SHEET NUMBER 4	DRAWN BY: AS SHOWN	SCALE: AS SHOWN	WINDLER - HARVEST ROAD INFRASTRUCTURE SITE PLAN HARVEST ROAD - 48TH AVE TO 56TH AVE ROADWAY PLANS	WINDLER PUBLIC IMPROVEMENT AUTHORITY 5750 DTC PARKWAY, SUITE 210 GREENWOOD VILLAGE, CO 80111 PHONE: (303) 795-9900	 10333 E DRY CREEK RD SUITE 240 ENGLEWOOD, CO 80112 TEL: 720.482.9526 Westwoodps.com Westwood Professional Services, Inc.
	CHECKED BY: DJD	DATE: August 2023	Revisions	No.

WINDLER - HARVEST ROAD INFRASTRUCTURE SITE PLAN
HARVEST ROAD - 48TH AVE TO 66TH AVE
ROADWAY PLANS

**HARVEST RD INFRASTRUCTURE SITE PLAN
48TH AVE TO 56TH AVE
LANDSCAPE PLAN**

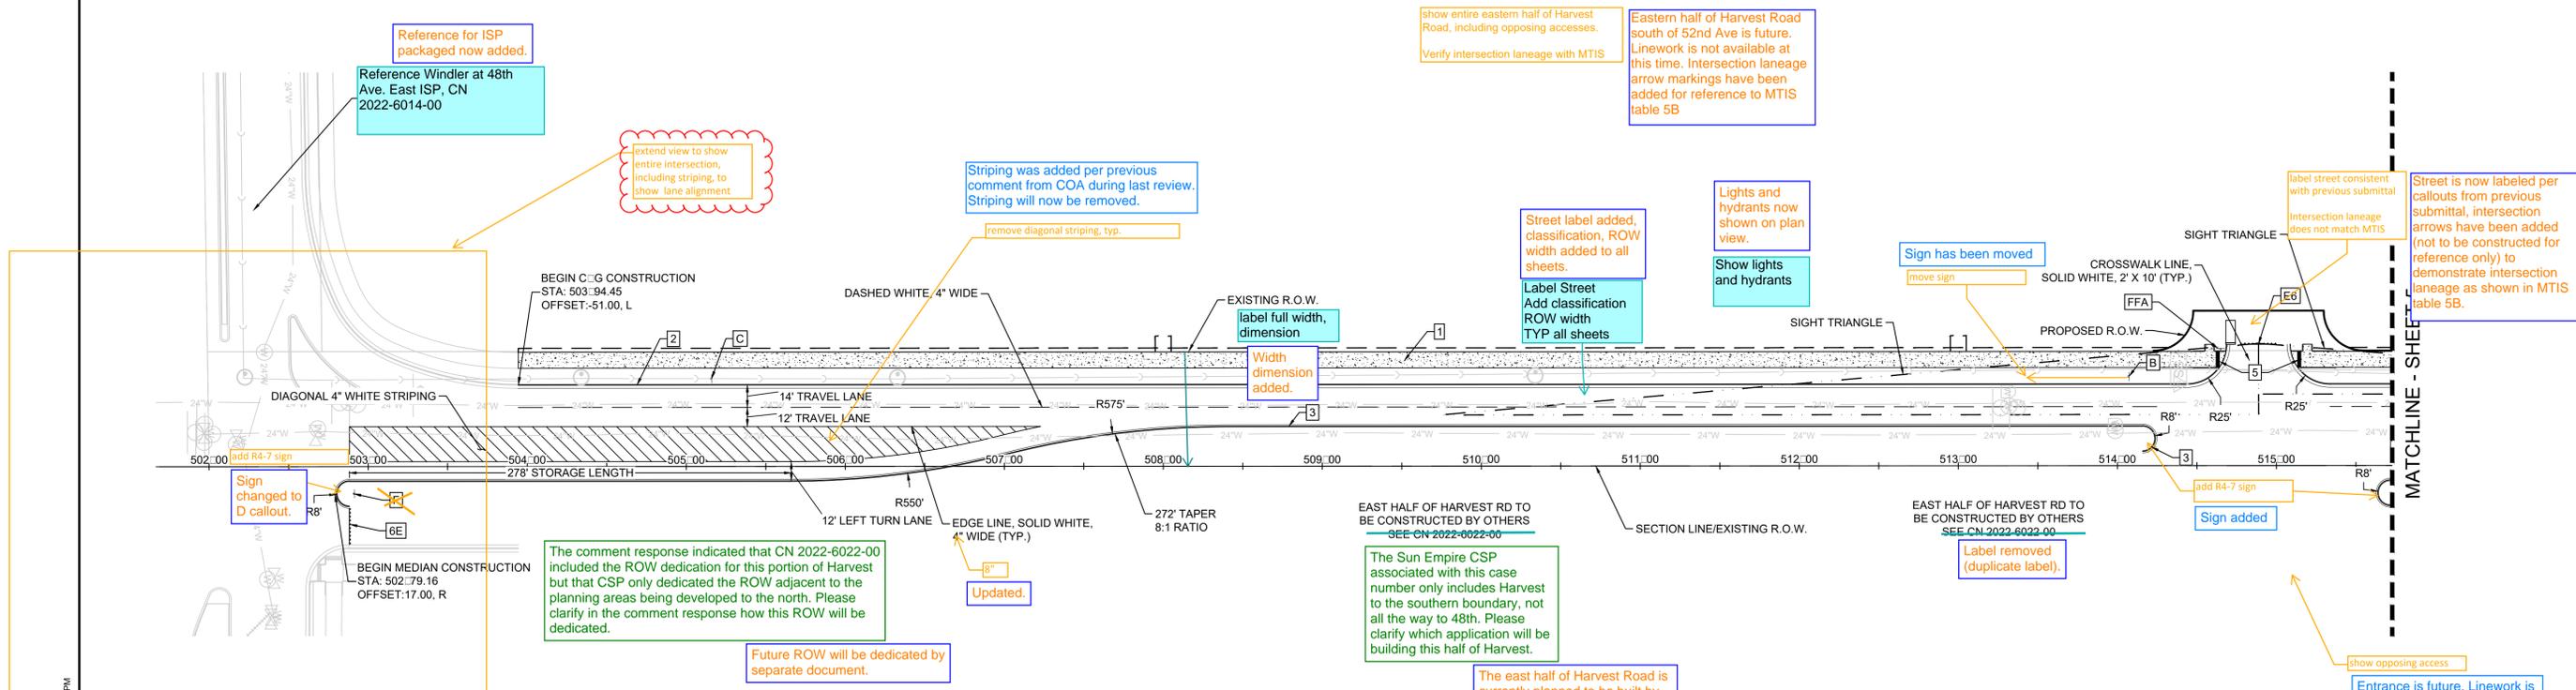
please increase font size

reference 48th Avenue ISP (ARTA) CN 2022-6047-00
CN number for ISP package added.

Font size and scale shown are correctly sized.

11

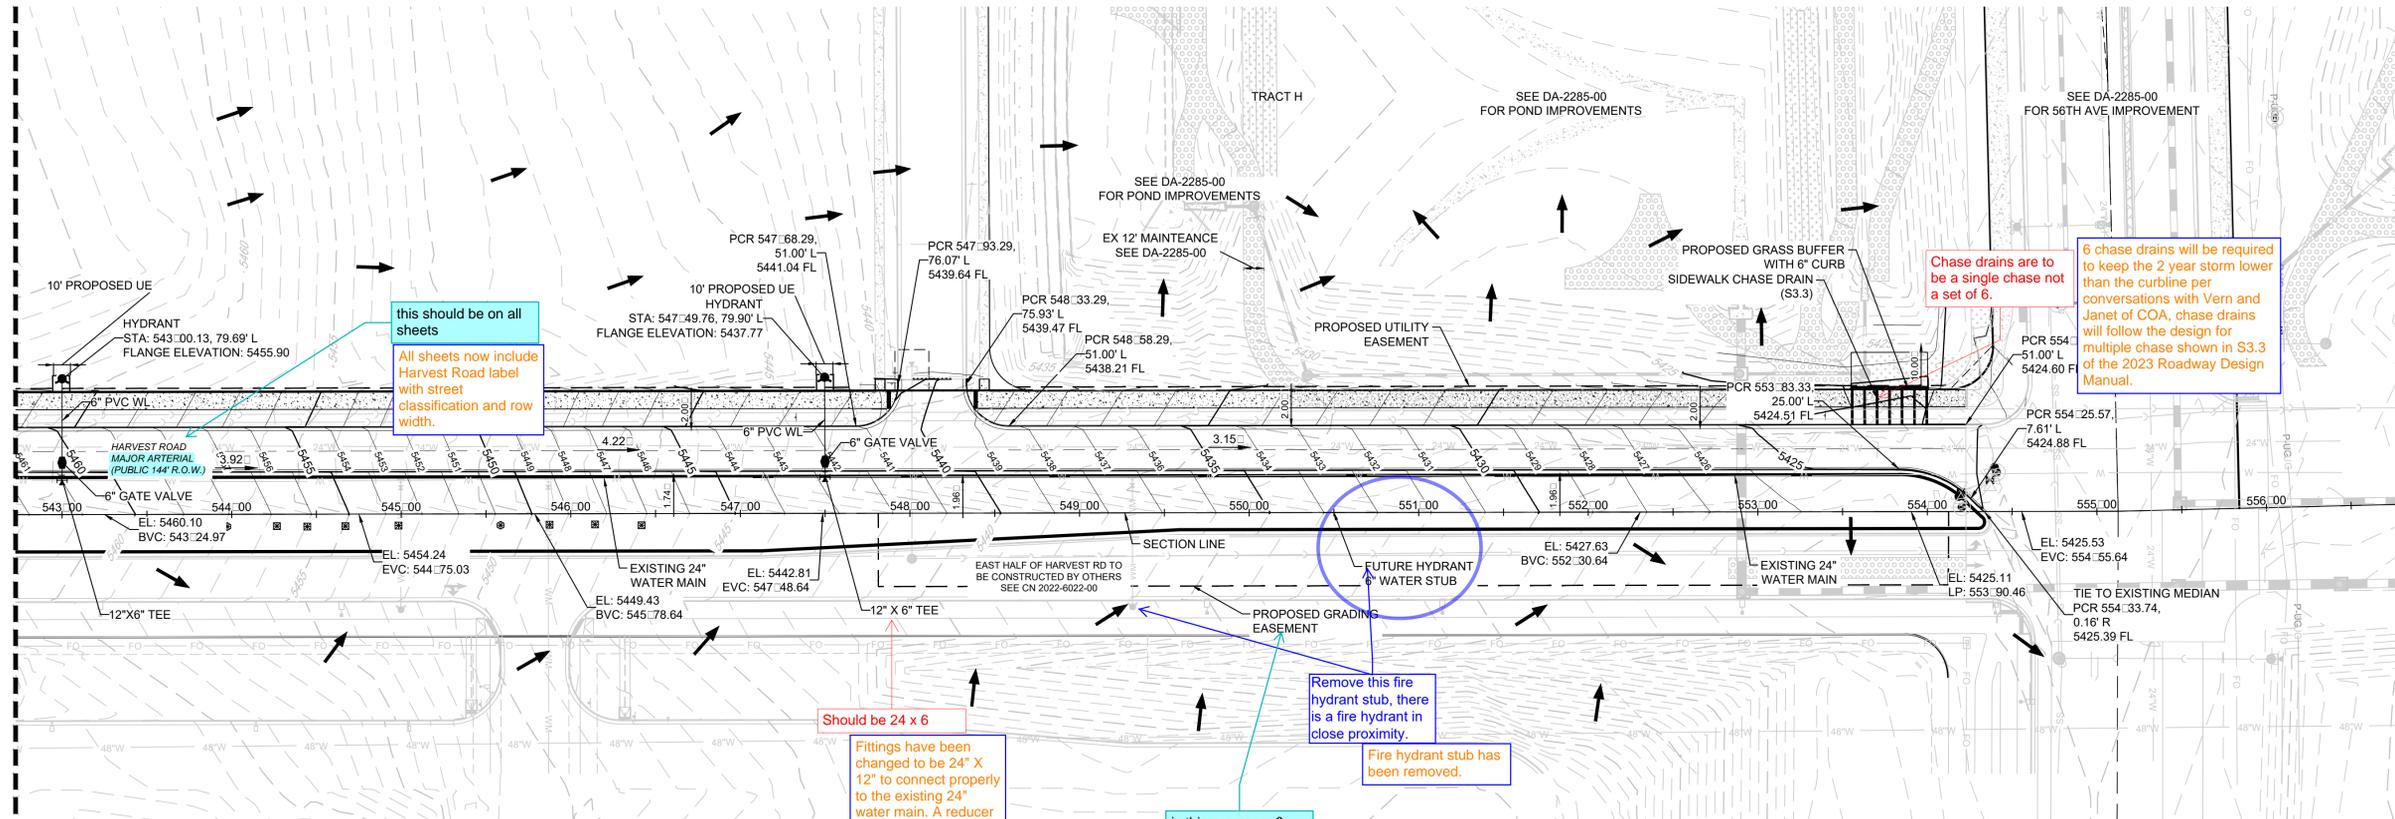
this should be on all sheets
All sheets now include Harvest Road label with street classification and row width.

Chase drains are to be a single chase not a set of 6.

Should be 24 x 6
Fittings have been changed to be 24" X 12" to connect properly to the existing 24" water main. A reducer has been added to connect to each lateral.

Remove this fire hydrant stub, there is a fire hydrant in close proximity.
Fire hydrant stub has been removed.

is this necessary?
East half of ROW is dedicated and will be constructed by others
Proposed grading easement has been removed.

6 chase drains will be required to keep the 2 year storm lower than the curbline per conversations with Vern and Janet of COA, chase drains will follow the design for multiple chase shown in S3.3 of the 2023 Roadway Design Manual.

SHEET NUMBER	13	SCALE:	AS SHOWN	FILE NO:	R0043248.00
DRAWN BY:	SG	CHECKED BY:	CV	DATE:	AUGUST 2023
Revisions	No.	Date	Appr.	Date

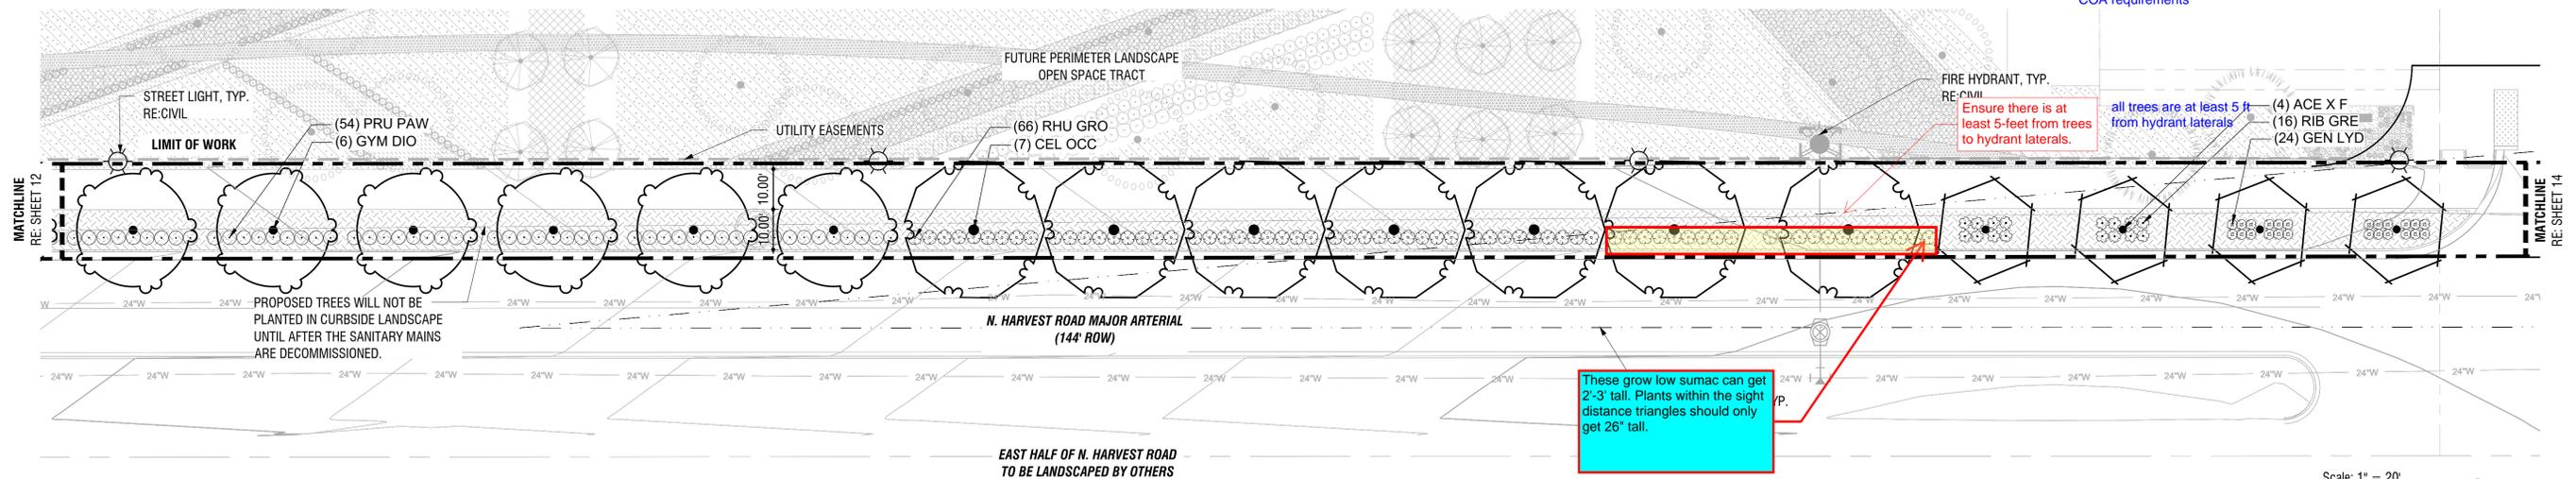
verify ALL mature plant heights within sight triangles meet COA 4.04.2.10 requirements, typ.
all plant heights within sight triangles meet COA requirements

Ensure there is at least 5-feet from trees to hydrant laterals.

These grow low sumac can get 2'-3' tall. Plants within the sight distance triangles should only get 26" tall.

all trees are at least 5 ft from hydrant laterals

Changed to Panchito manzanita

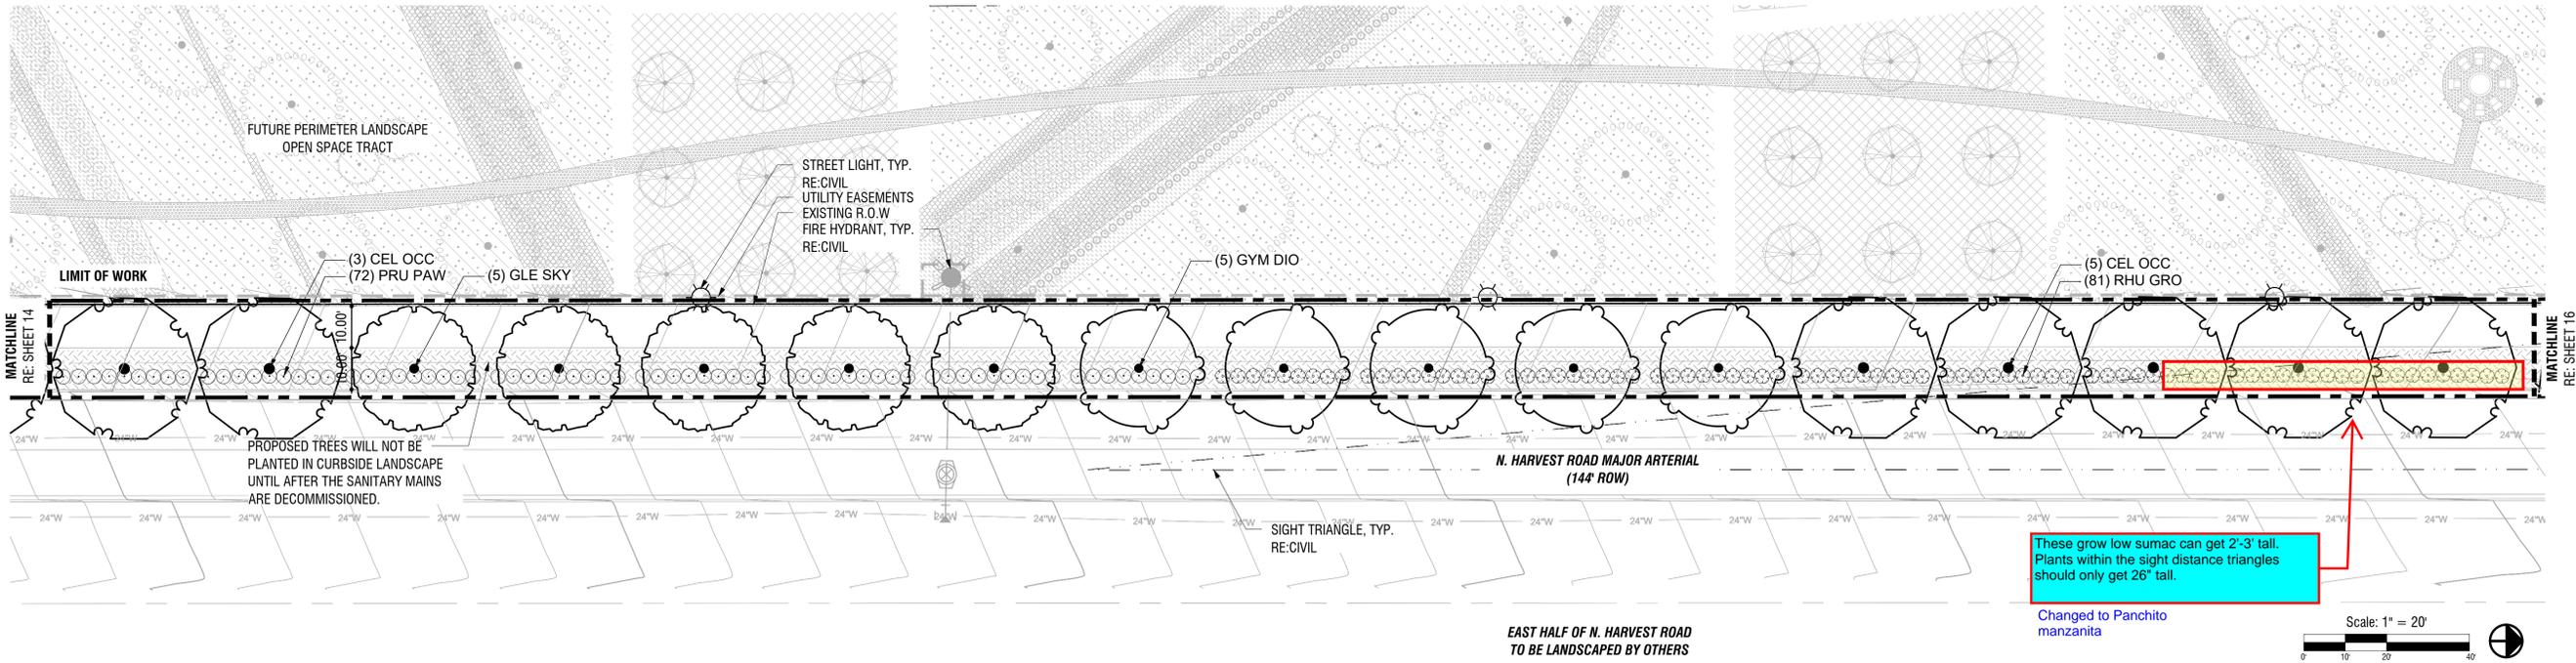
These grow low sumac can get 2-3' tall.
Plants within the sight distance triangles
should only get 26\"/>

Changed to Panchito
manzanita

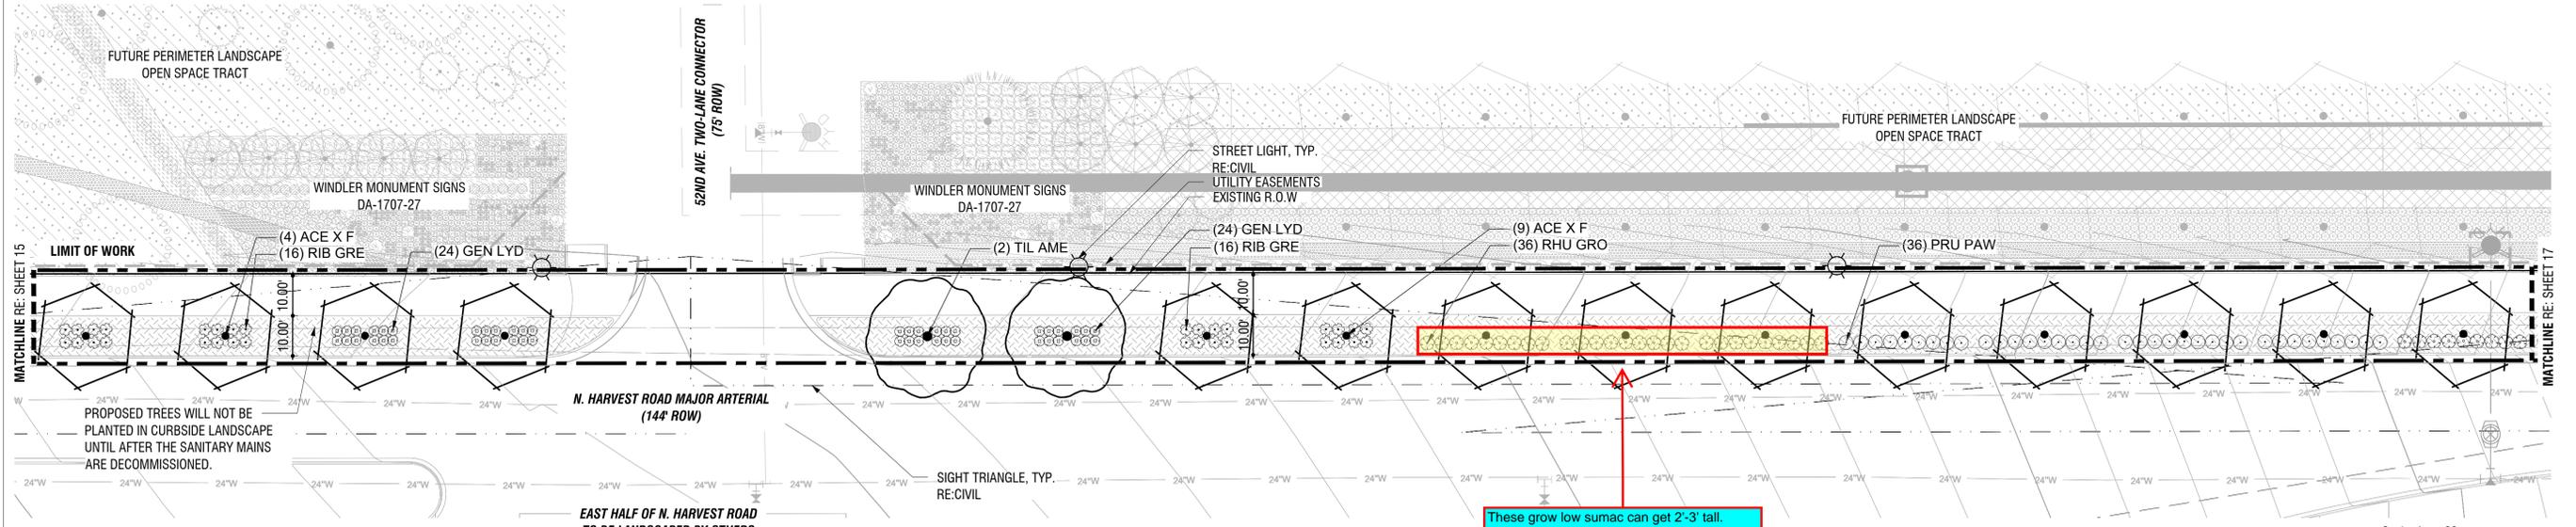
These grow low sumac can get 2'-3' tall. Plants within the sight distance triangles should only get 26" tall.

Changed to Panchito manzanita

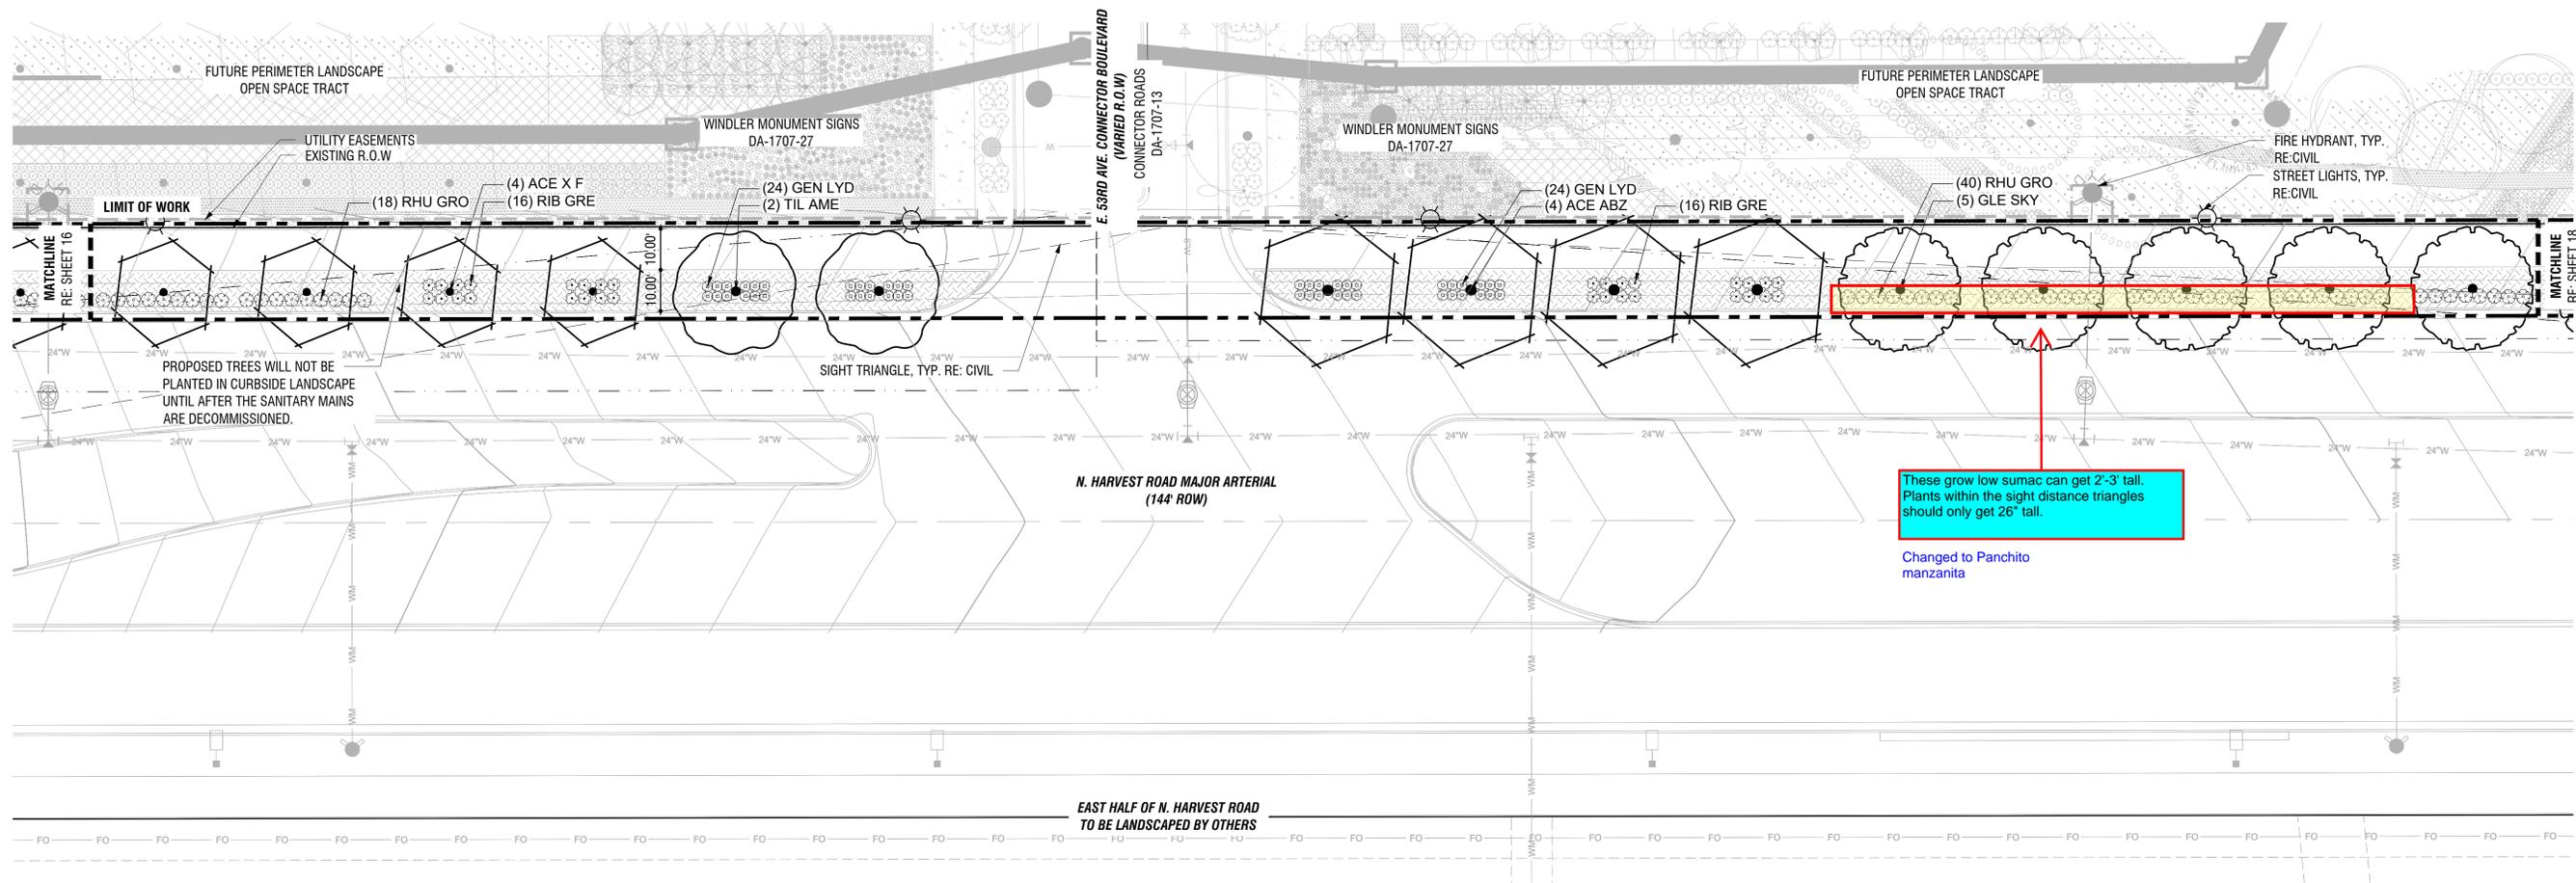
These grow low sumac can get 2'-3' tall. Plants within the sight distance triangles should only get 26" tall.

Changed to Panchito manzanita
